RE: **Black Warrior Minerals, Inc.**  
Mine No. 1, P-3950, Revision R-5, Request for Delay in Contemporaneous Reclamation

RE: **Black Warrior Minerals, Inc.**  
Mine No. 1, P-3950, Revision R-5, Request for Delay in Contemporaneous Reclamation  
Requested Additional Information

**BLACK WARRIOR MINERALS, INC.**  
MINE NO. 1, P-3950, R-5  
CUT LAYOUT MAP - Grading Delay Request

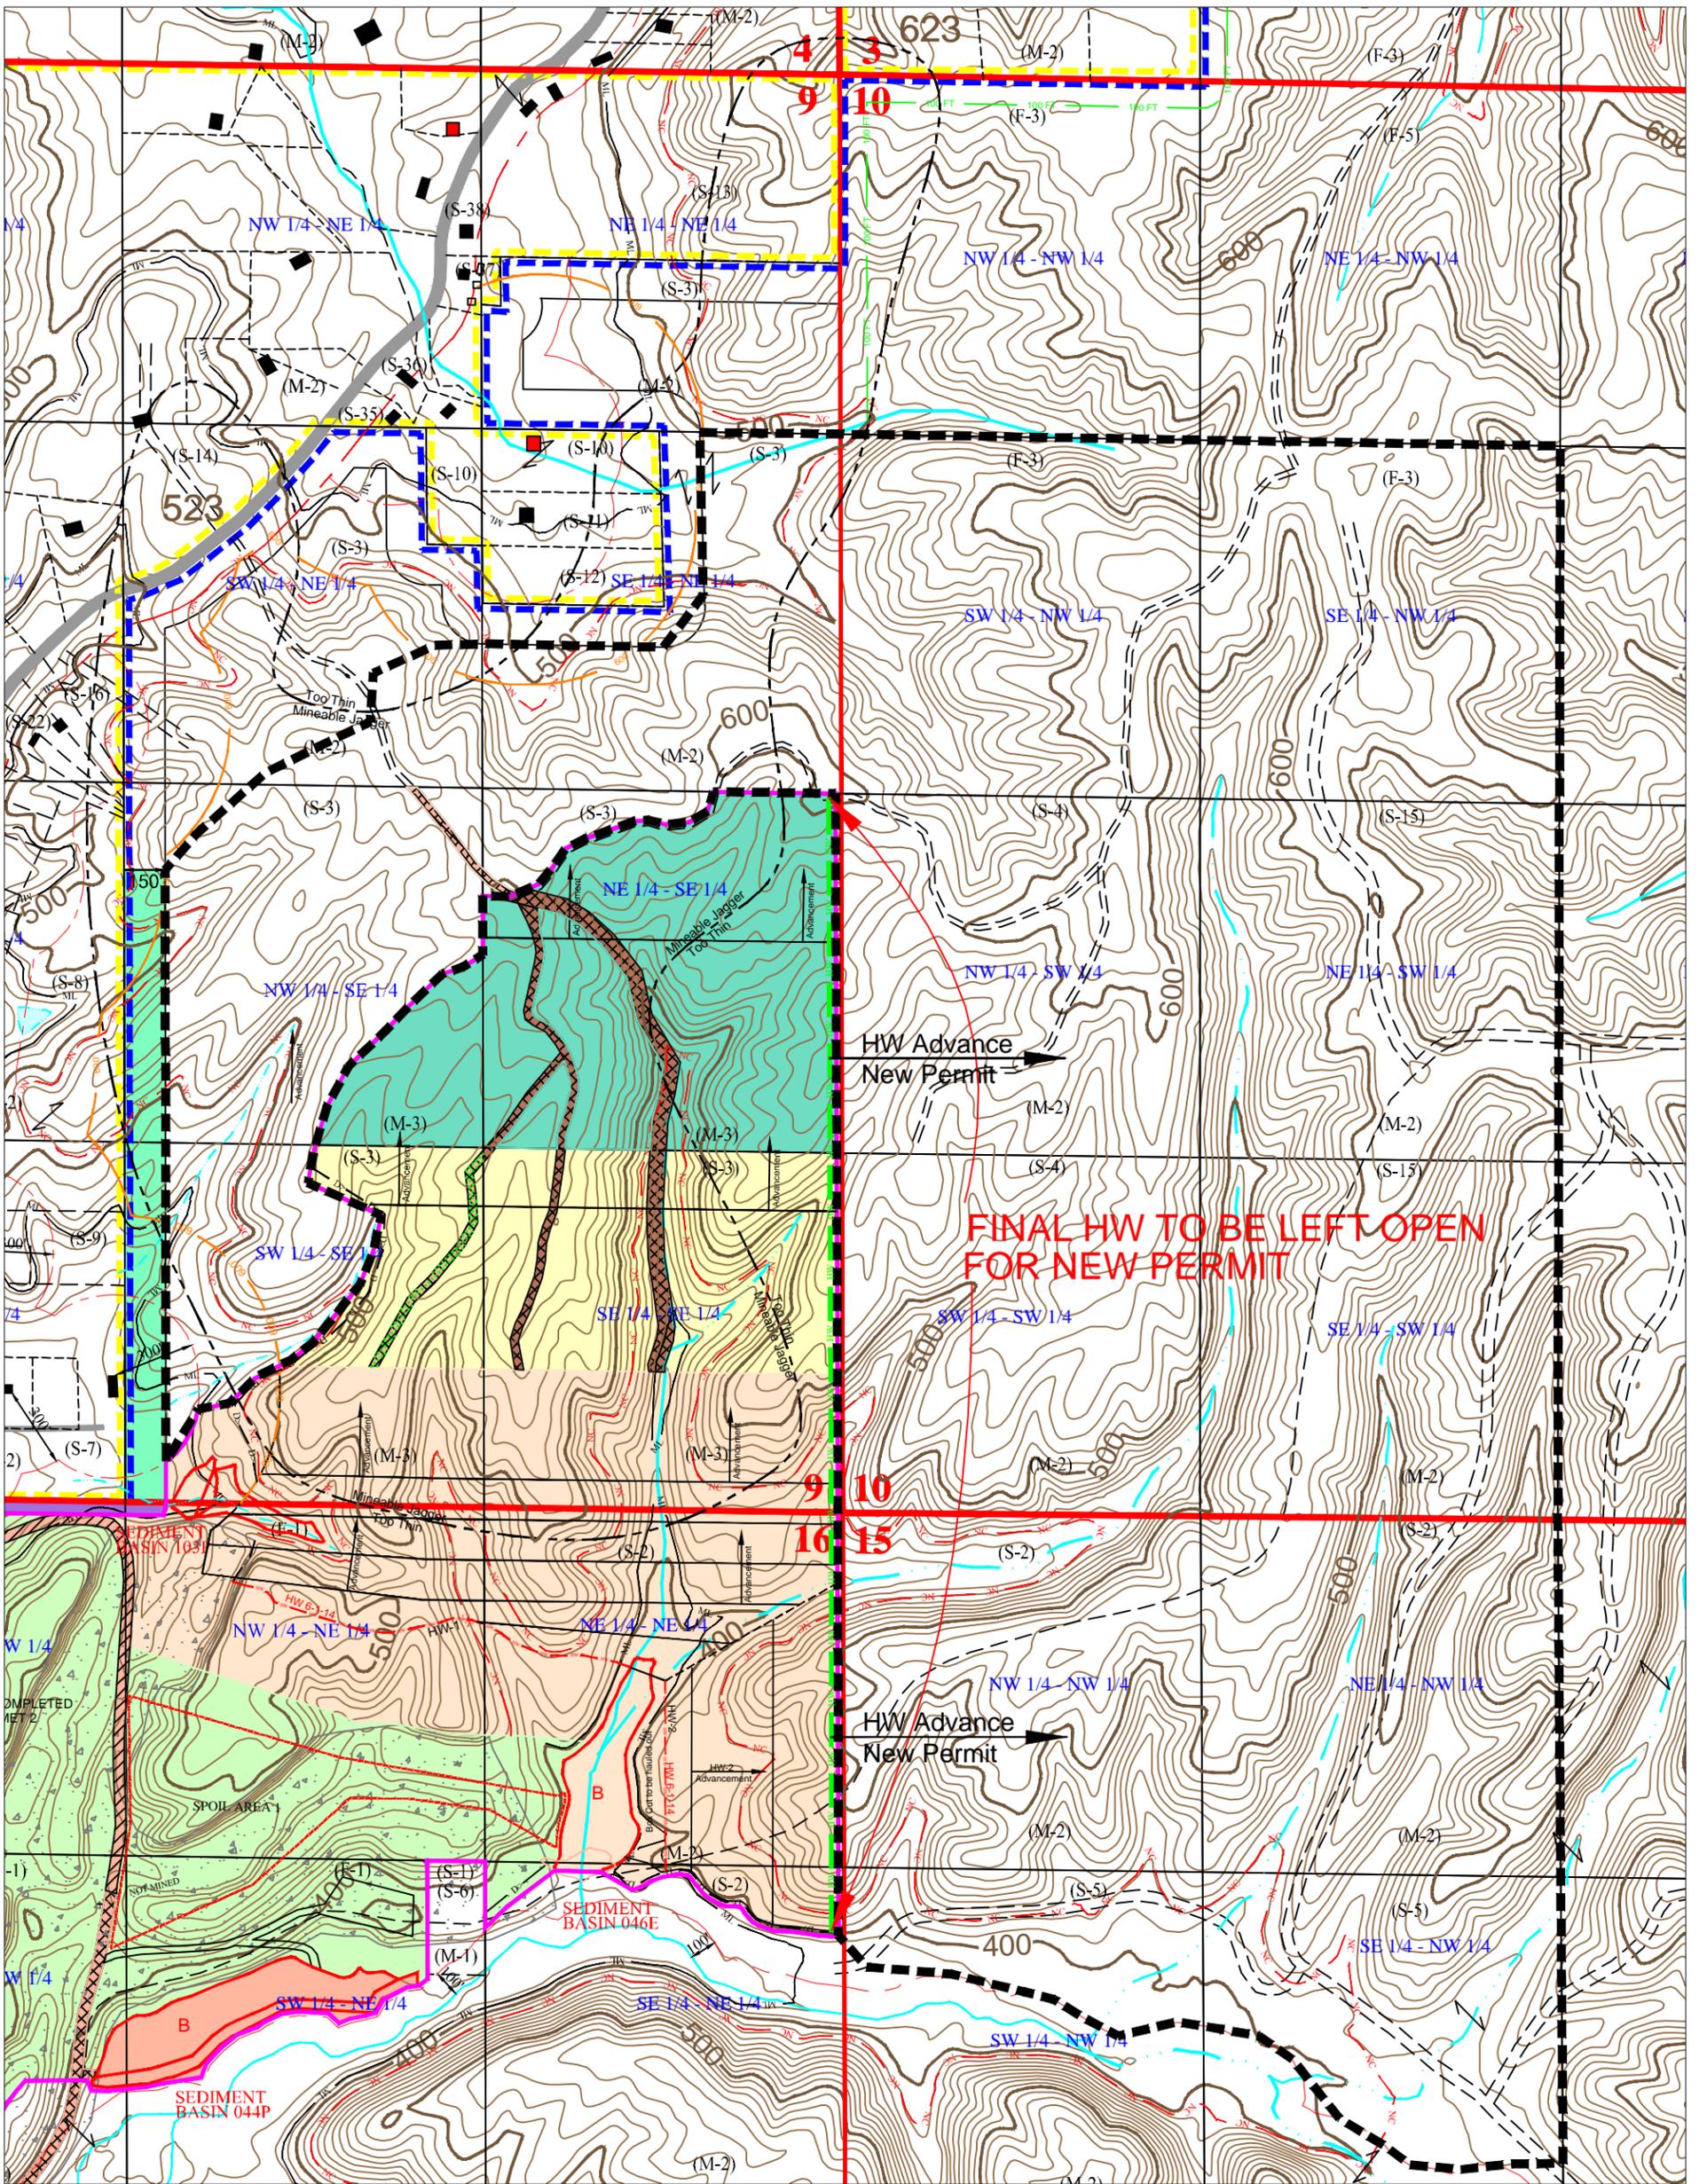
Revision R-5 proposes to modify the operation plan and cut layout. Mining has advanced into Increment No. 3 in two different areas as shown on the Cut Layout Map. HW-1 is northwest of Basin 046 that is aligned basically west to east and is advancing to the north. HW-2 is on the east side of Basin 046 and is aligned north to south and is advancing to the east. The north end of the cuts of HW-2 will extend slightly to the north each cut stopping just short of the east main drain of Basin 046. The north end of the cuts of HW-2 will be left open for spoiling room for HW-1. The cuts on the north end of HW-2 will be left open for a period of 6-8 months.

As HW-1 advances to the north, it is proposed to leave the far east end of Increments 3, 4 and 5 open for a pit access, pit drainage and for spoiling room for the existing permit. The final pit of HW-2 will also be left open. The final high wall will remain open until mining is completed in Increment 5.

Black Warrior Minerals is currently preparing a new permit that will add substantial area to the east of Increments 3, 4 and 5 in Section 10 & 15. Black Warrior Minerals is proposing to leave the entire final high wall along the eastern permit boundary of Increments 3, 4 & 5 open for pit access, pit drainage and spoil room for the new permit. Black Warrior Minerals respectfully requests one delay in contemporaneous reclamation be granted for the cuts on the north end of HW-2 for a period of 6-8 months and a second delay for the final high wall (approximately 4,200 linear feet) along the east permit boundary of Increment 3, 4 & 5 be granted.
